SUBJECT: M20M LANDING GEAR RIGGING INSPECTION AND MODIFICATION.

S/N AFFECTED: **M20M - S/N 27-0107 THRU 27-0147** - (S/N's 27-0115, 27-0123, 27-0127, 27-0131, 27-0137, 27-0142, 27-0144, 27-0150 HAVE HAD INSTRUCTIONS OF SB ACCOMPLISHED).

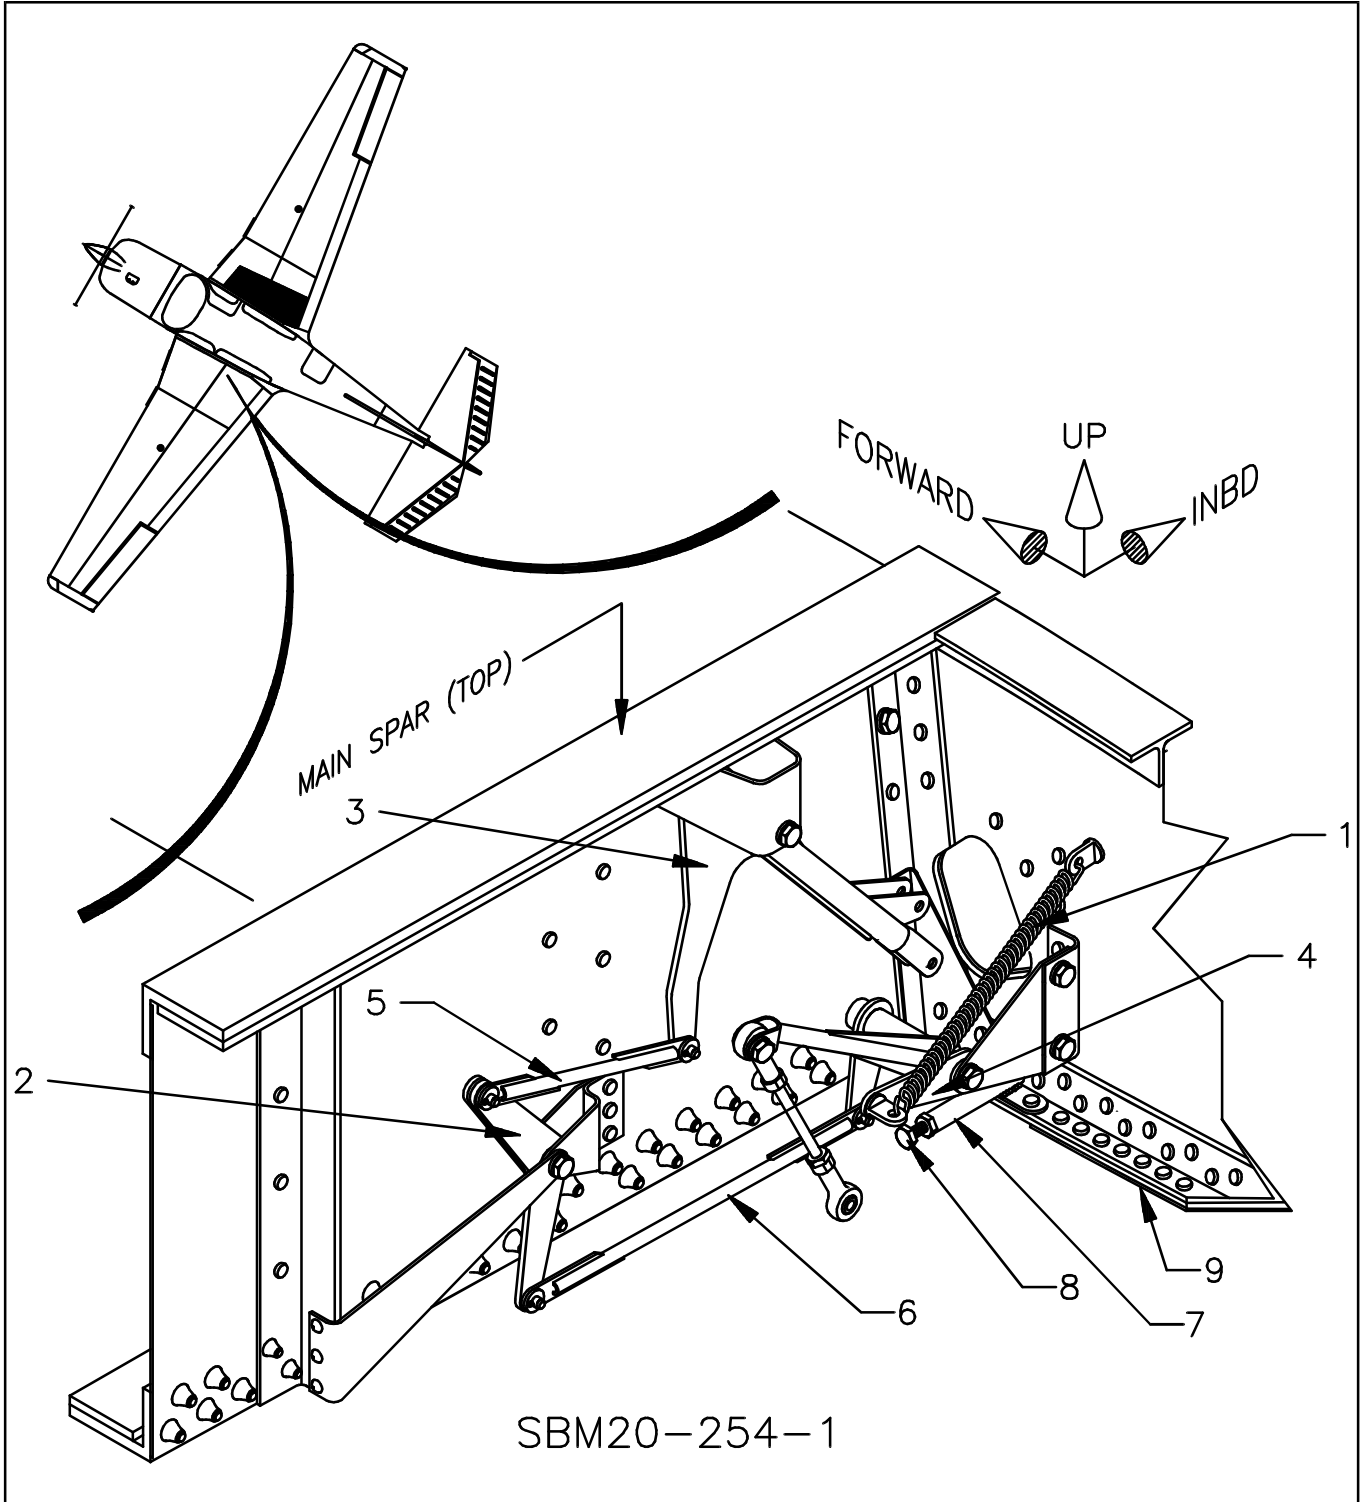
6. Aircraft still on jacks. Landing gear down and locked.
7. Locate the two rivets on LH & RH wheelwells that are just forward of the inboard gear door hinge (9) attaching rivets (Ref. Fig M20-254-1). This is the location for the 550075-501 stops (7) to be installed.
8. Disconnect Inboard Gear doors. Carefully drill off the two rivet heads on LH & RH sides; punch rivets out.

**550075-501 stop (7) has two #40 pilot holes in flange. In some instances, due to manufacturing tolerances, the pilot holes may not align exactly with both drilled holes in wing rib. If this is the case, determine which of the two holes in stop flange will create the better alignment of the stop bolt head (8) with the bellcrank (4) arm. Use this hole as the "primary" attachment hole.**

9. Drill "primary" attachment hole to size (#20 drill) in each stop. Cleco stops (7) in place, at "primary" attach hole only, so head of bolt (8) in stop aligns with arm of inboard gear door bellcrank (4) that spring (1) is attached to.

10. When stop (7) is clecoed in proper position, drill second attach hole in stop flange to size (#20 drill), by back drilling through existing "non-primary" rivet hole. Deburr hole in flange and cleco in position. Make sure head of bolt (8) in stop aligns (directly centered) with arm of bellcrank (4).

11. Rivet stops (7), P/N 550075-501, in each wheelwell at the location described in steps 8 & 9 above using rivets included in this kit. Re-attach Inboard Gear doors before cycling landing gear for following steps.
12. Leave spring (1) attached to clevis of inboard door bellcrank (4). Bolt head (8) should be screwed all the way in.

SBM20-254-2

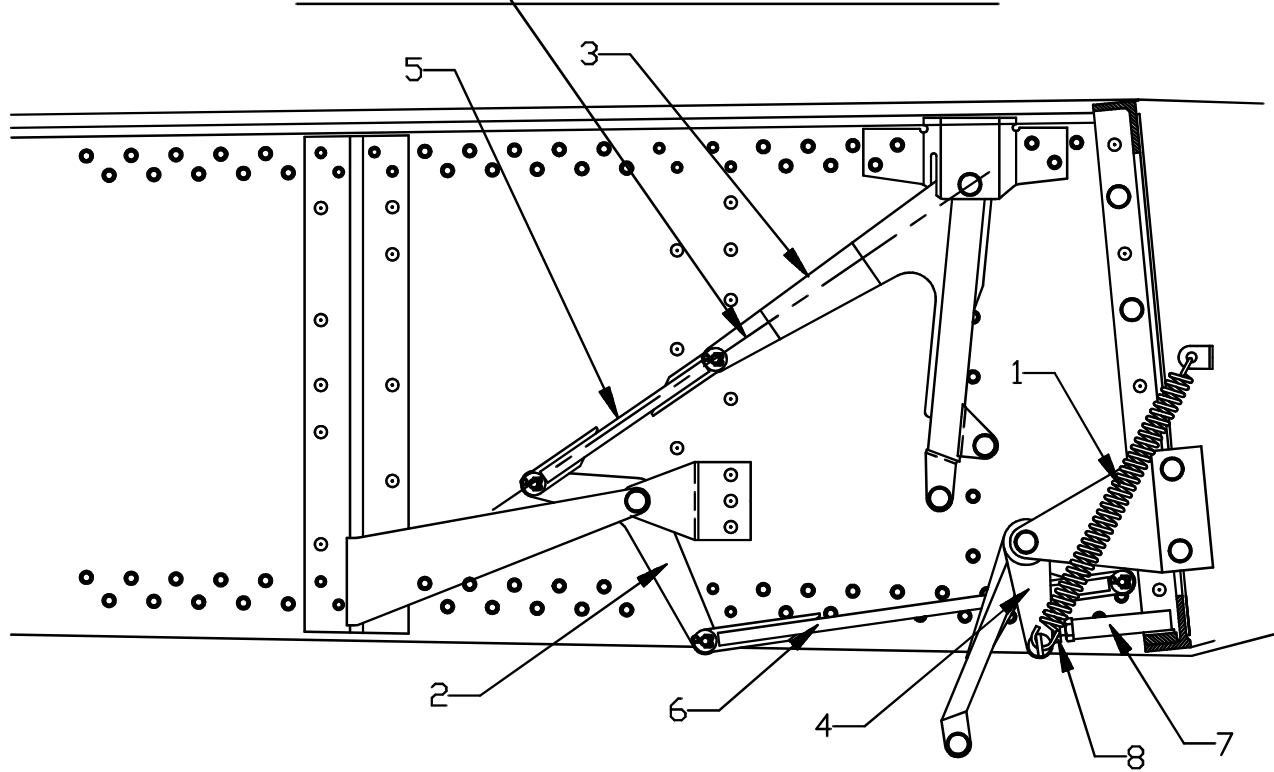
13. Retract landing gear using safety by-pass switch (See S & M, Section 32-30-01, steps 5, 6, 7) until inboard gear door has traveled as far as it will go during its retraction cycle. In this position, the pivot points of bellcrank (3) & center line of rod (5) will be in a straight line (Reference Figure M20-254-2). Components (2), (5) & (6) should now be in a loaded condition and feel very tight.

NOTICE  
THESE PIVOT POINTS ARE IN ALMOST A STRAIGHT LINE.  
THIS REPRESENTS THE MOST EXTREME TRAVEL THAT THESE  
COMPONENTS SHOULD BE.

14. Adjust stop bolt head (8) OUT until it rests on bellcrank (4) arm. Continue to adjust bolt head OUT until rods (5) & (6) become loose (no load felt on either rod). Bellcrank (2) will also become loose when bolt head (8) is in correct position. Tighten jam nut on bolt (8) against tube on stop (7).
